SUBJECT: **Safety Recall 04S20: Supplement #5**
All 2002 and Certain 2003 Model Year Ford 4-Door Explorer & Mercury Mountaineer Vehicles - Liftgate Glass Hinge and Ball Stud Bracket (if applicable) Replacement

Ref: **Safety Recall 04S20: Supplement #4** dated 12/21/04
Ref: **Safety Recall 04S20: Supplement #3** dated 12/9/04
Ref: **Safety Recall 04S20: Supplement #2** dated 12/6/04
Ref: **Safety Recall 04S20: Supplement #1** dated 11/16/04
Ref: **Safety Recall 04S20: Original Bulletin** dated 9/24/04
Ref: **Advance Notice - Safety Recall 04S20** dated 9/9/04

**CERTAIN 2002 AND 2003 MODEL YEAR EXPLORER/MOUNTAINEER VEHICLES —
LIFTGATE GLASS BALL STUD BRACKET AND HINGE REPLACEMENT**

FIGURE 1

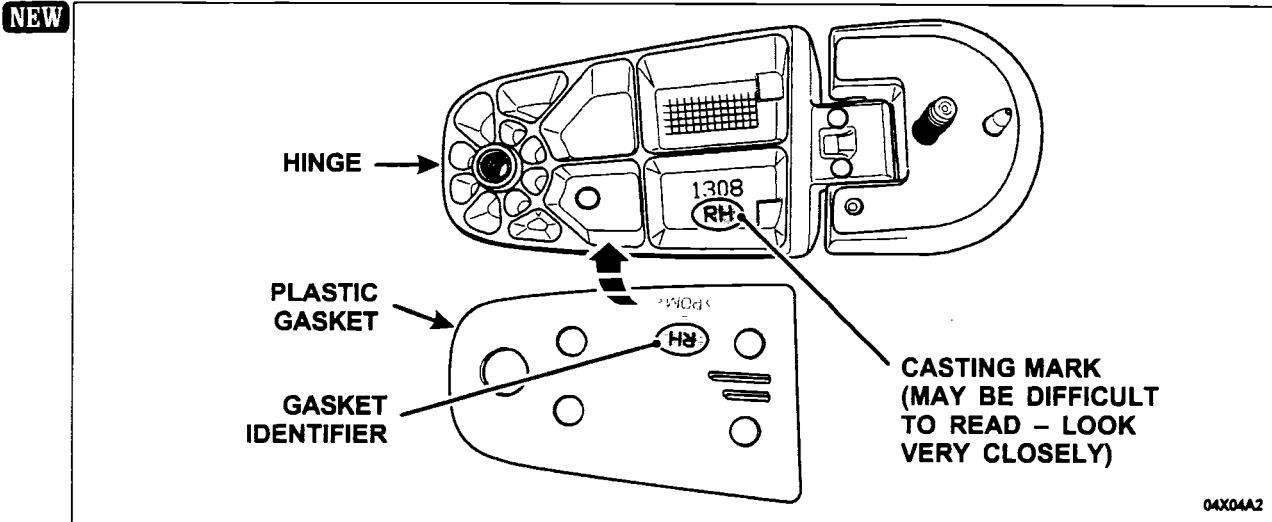
WARNING: THE *NEW* HINGES AND PLASTIC HINGE GASKETS ARE IDENTIFIED AS EITHER RIGHT-HAND OR LEFT-HAND (PASSENGER SIDE OR DRIVER SIDE). IF INSTALLED ON THE WRONG SIDE OF THE VEHICLE, THE GLASS MAY SHATTER. SEE FIGURE 1 FOR IDENTIFICATION DETAILS.

NOTE: On some hinges the casting marks are very light and difficult to read. Look closely to make sure each bracket is properly identified.

FIGURE 3

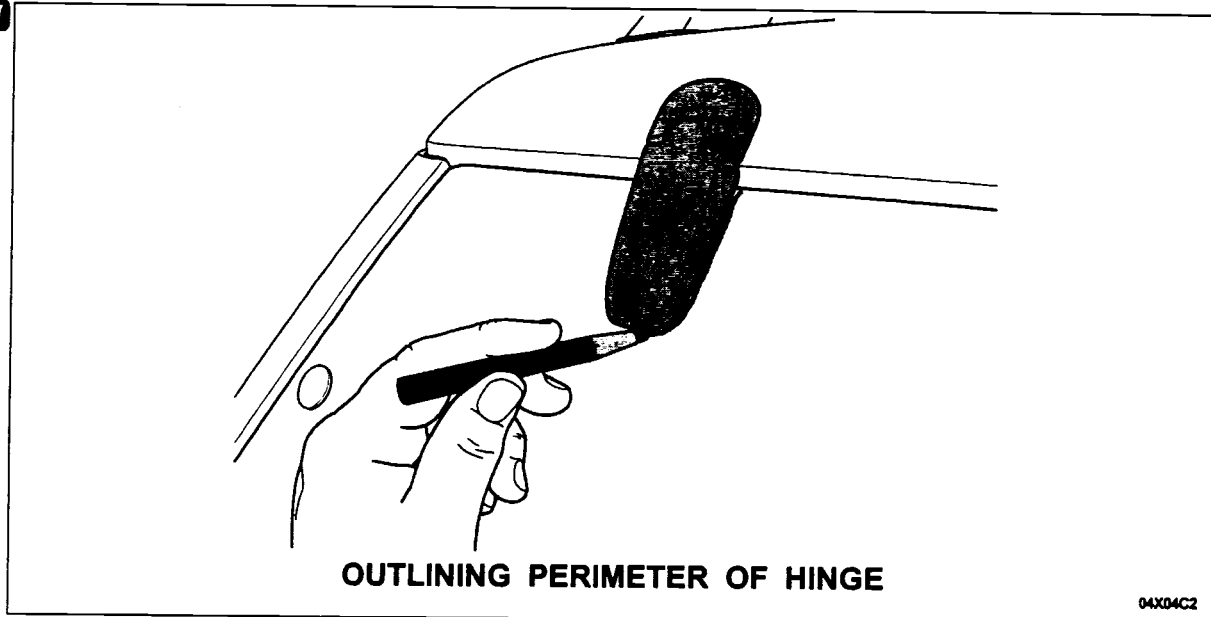
4. **CAUTION: The location of the original glass hinges must be clearly marked on the glass to make sure the *new* hinges are accurately positioned and that the glass is properly aligned. Failure to properly align the *new* hinges to these marks may result in glass shattering.**

Using a grease pencil, a non-permanent marker or tape, outline the entire perimeter of the original hinges to mark their exact location on the glass. See Figure 3.

FIGURE 5

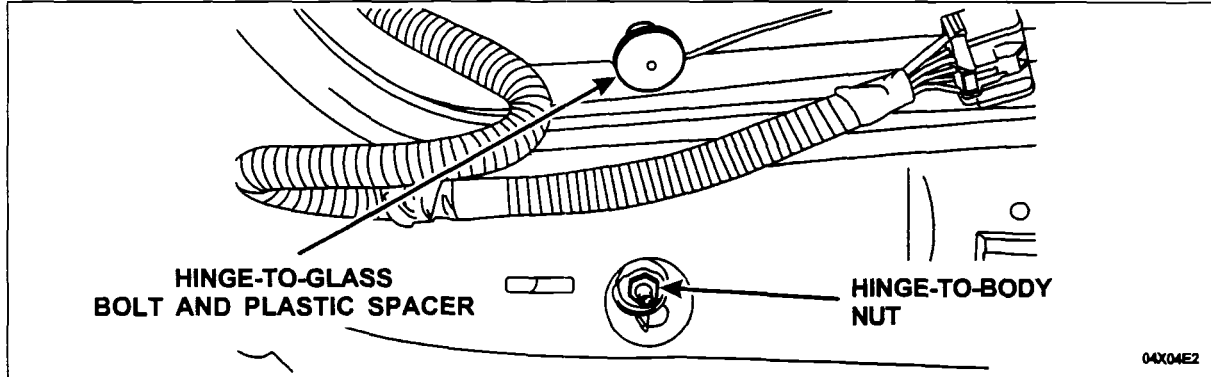
- Using a magnetic socket or tool, remove one (1) liftgate glass hinge-to-body nut, then the hinge-to-glass bolt and remove one (1) hinge from the vehicle. Retain the plastic spacers from the hinge-to-glass bolts for use with the *new* bolts. See Figure 5.

- Clean the glass, particularly at the edge around the hole, then inspect the edge of the hole in the glass to see if it is chipped or cracked. If the glass is chipped or cracked, the glass must be replaced. Discontinue this service in lieu of liftgate glass replacement.

FIGURE 6

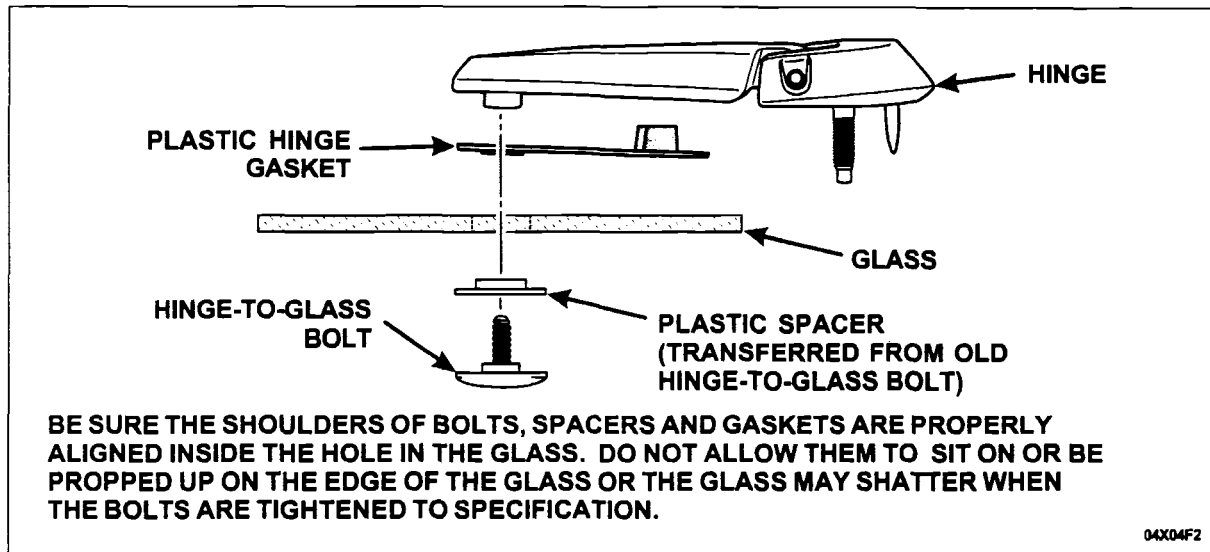
WARNING: THE PLASTIC SPACER LOCATED UNDER THE ORIGINAL HINGE-TO-GLASS BOLT MUST BE TRANSFERRED TO THE *NEW* BOLT. FAILURE TO INSTALL THIS SPACER WILL RESULT IN SHATTERING THE GLASS UPON BOLT INSTALLATION. SEE FIGURE 6.

WARNING: THE PLASTIC SPACER LOCATED UNDER THE ORIGINAL HINGE-TO-GLASS BOLT MUST BE CLEANED AND TRANSFERRED TO THE *NEW* BOLT. FAILURE TO INSTALL THIS SPACER WILL RESULT IN SHATTERING THE GLASS UPON BOLT INSTALLATION. SEE FIGURE 6.

FIGURE 11

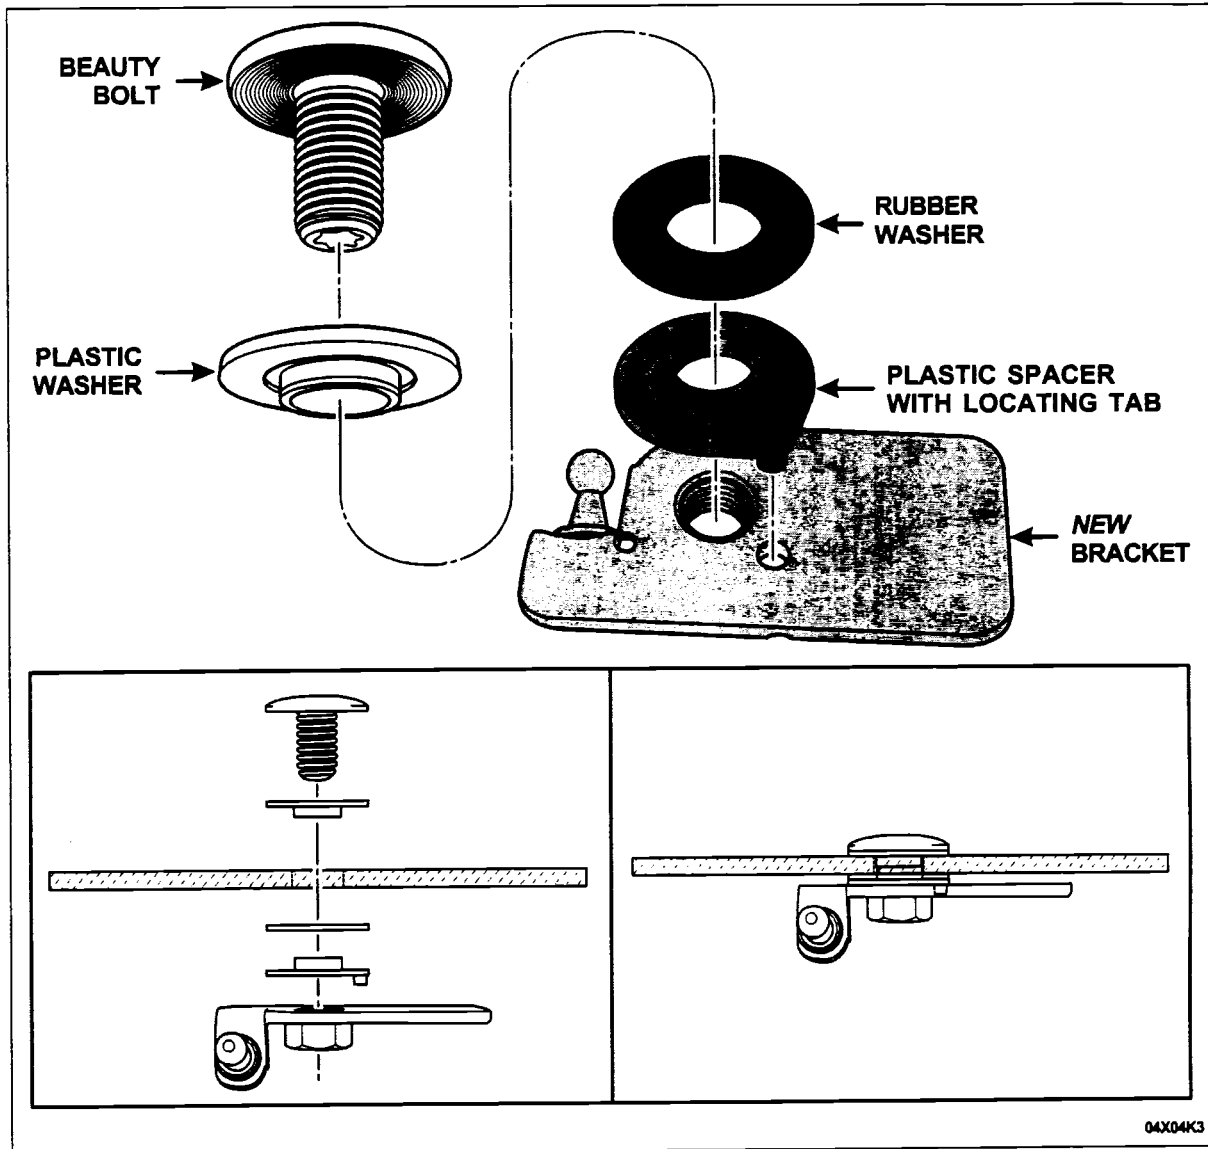
8. **CAUTION:** Be sure the glass and plastic washers are very clean and contain no grit, dirt, sand or any other foreign matter prior to installation. Even the smallest bit of any hard material captured between the plastic washer and the glass may cause the glass to shatter.

Install the plastic spacer (with locating tab) and rubber washer onto the *new* brackets as shown in Figure 11. Also, place a plastic washer onto the beauty bolt with the collar toward the glass.

FIGURE 14

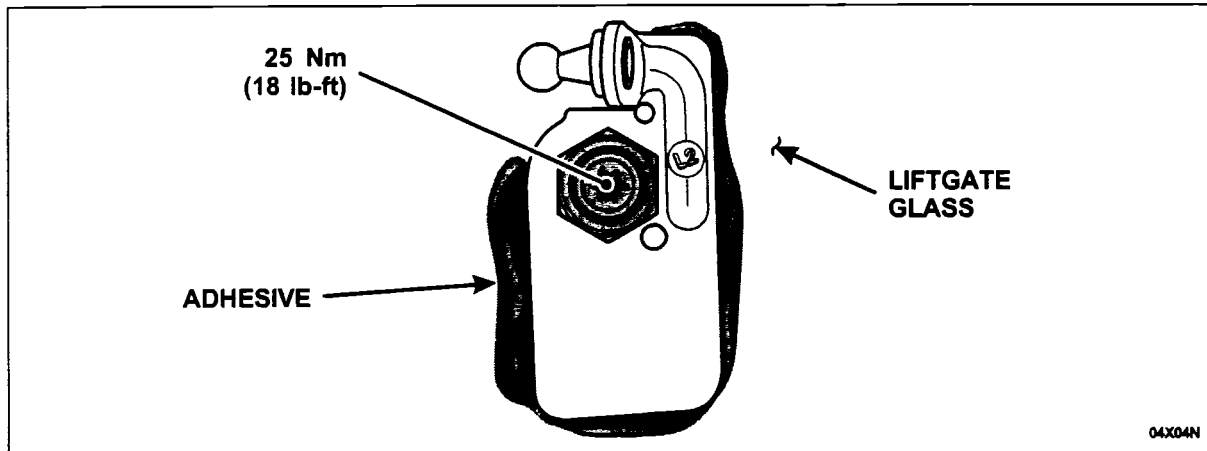
CAUTION: When working with glass, the torque specifications are very critical. Be sure the torque wrench used during this service has recently been calibrated so the fasteners are not over-tightened or under-tightened. Failure to use a calibrated torque wrench may result in glass shattering either during the repair or possibly after the repair is completed.

While holding the bracket nut with a 17-mm box or open-end wrench, tighten the bolt to 25 Nm (18 lb-ft). See Figure 14.

THE REPLACEMENT GLASS MUST HAVE:

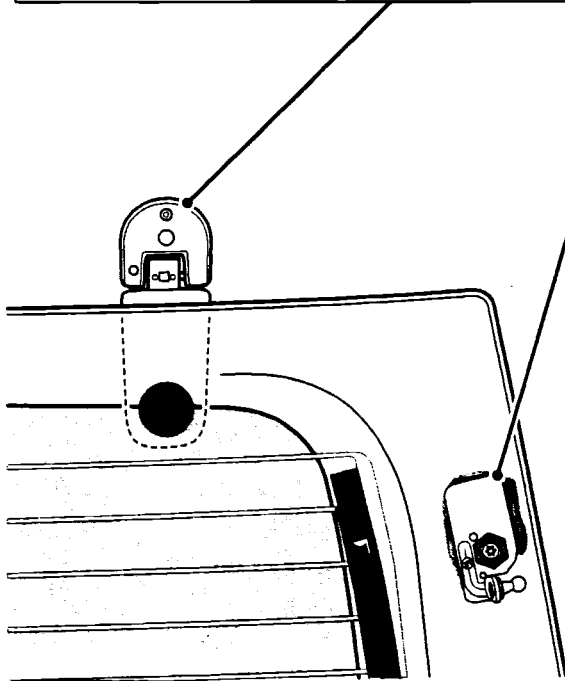
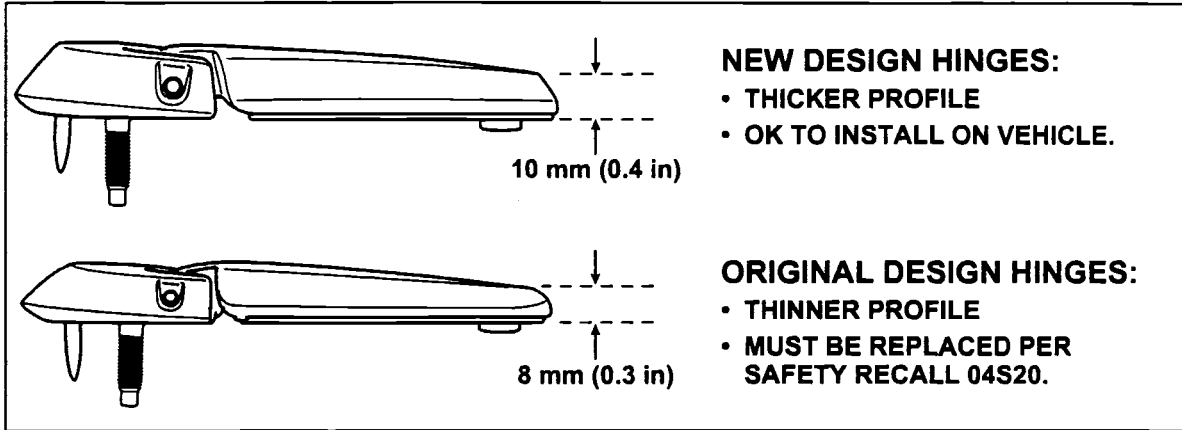
- Thick design hinges
- Large strut brackets
- Hard adhesive

- The new design hinges.
- Large strut brackets.
- Hard adhesive.

CAUTION: ATTEMPTING TO REMOVE A BRACKET THAT IS ATTACHED WITH THE NEW (HARD-TO-THE-TOUCH) ADHESIVE WILL LIKELY RESULT IN SHATTERING OF THE LIFTGATE GLASS.
